**RE: Advanced Auto Parts
Grading and Drainage Plan
Engineer's Stamp Date 9-15-2015 (File: H14D041)**

**RE: Advanced Auto Parts
Grading and Drainage Plan
Engineer's Stamp Date 8-17-2015 (File: H14D041)**

GRADING AND
DRAINAGE PLAN

D4 CONCRETE CHANNEL DETAIL

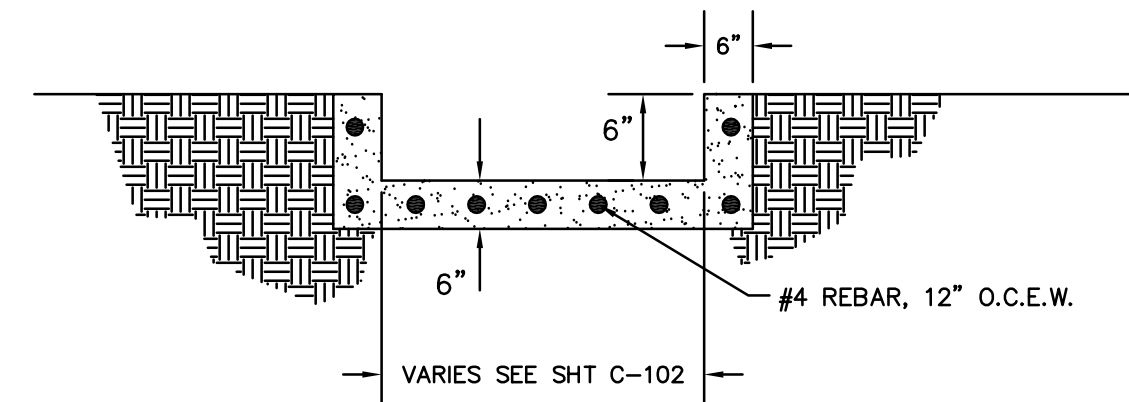
1. Keyed note #9 must be modified to add that the SW culvert (both plate and channel) must be extended 2ft. past the back of Sidewalk. Note that the bolts must be tack welded to the plate.
2. Keyed note #7 must be modified. An open concrete channel presents a tripping hazard. If there is sidewalk, then a Sidewalk culvert should be used (extended per above comment). It is unclear if there is Sidewalk. If there is not sidewalk, then the channel should be an earthen channel filled with riprap to avoid falling into it.

6. Keyed notes should refer to the Detail on the Sheet C-501 (ie. See Detail D4 on Sht C-501):
See key notes on sheet C-102 and details on sheet C-501.
7. Pond #2 has a 2:1 slope. More than a 3:1 slope required slope stabilization measures. Large cobbles are typically used.:
6" of 2"-3" cobble stones will be used for stabilization measures. See sheet C-102 for key note and C-501 for detail.

A4 TYPICAL WATER HARVEST AREA NO. 2 (FUTURE) SECTION DETAIL

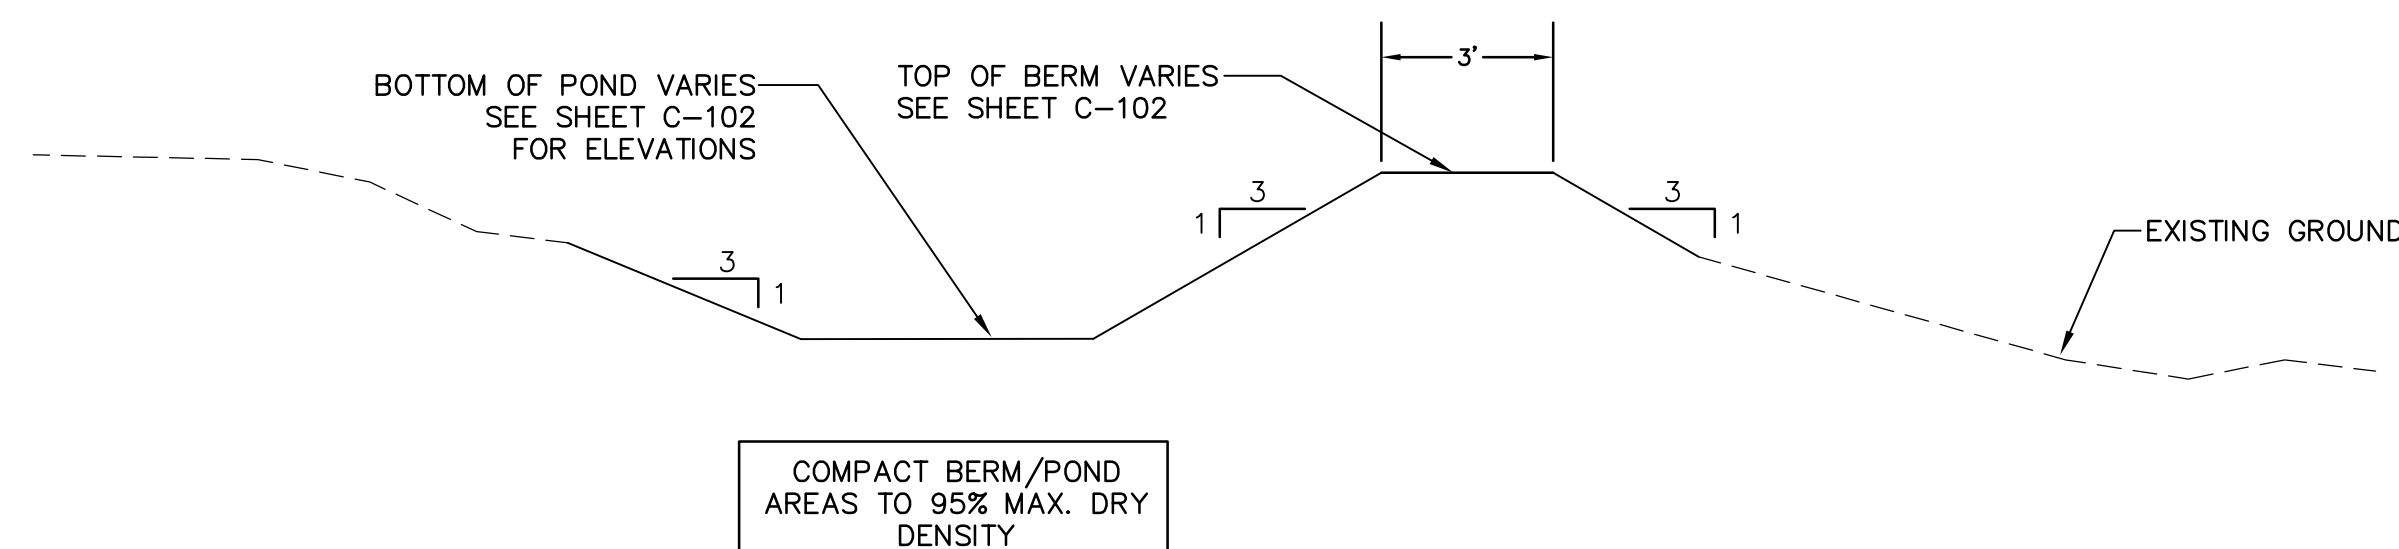
- vi. Future Pond #2 should be a detention pond, only retaining the First Flush and then discharging at a rate of 2.75cfs/Ac. The discharge mechanism will need to be designed.

Future Pond # 2 retains the 100-Year-24 hour storm which is extremely conservative in that it exceeds the ½" retention requirement in the Valley (per COA Hydrology Staff Valley Rule). The overflow future devise is a concrete channel and a standard 24" sidewalk culvert.
